Revision-02

MOTORIZED ROLLING SHUTTER

CLIENT - SCON PROJECTS

If any queries contact :design@nihva.com | DWG. NO. : NIHVA/21-22/0210 | REV- 02

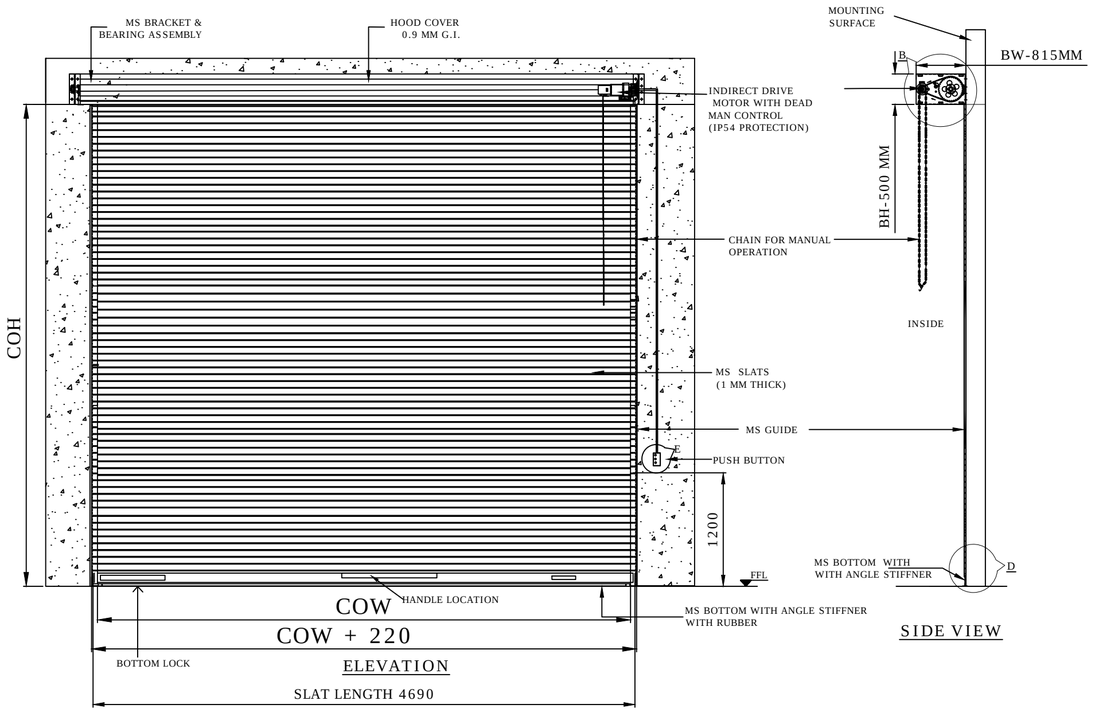
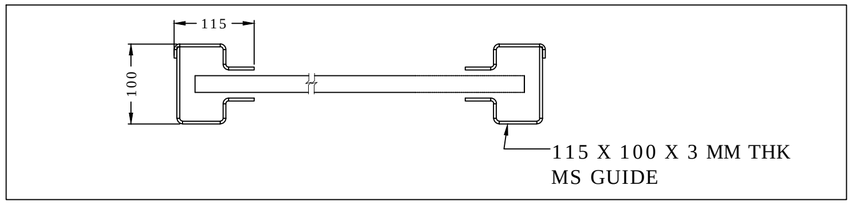
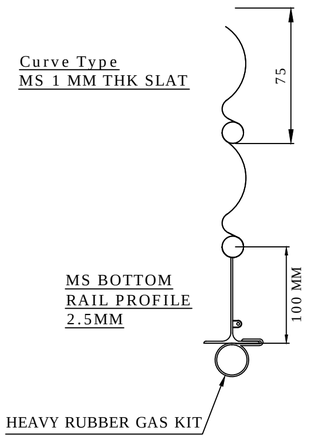
1. Motor bracket size changed.
2. Slat length and shaft length added.
3. Shaft bracket dimensions added.
4. Side bracket length modified.
5. Clear height changed to 5900mm.
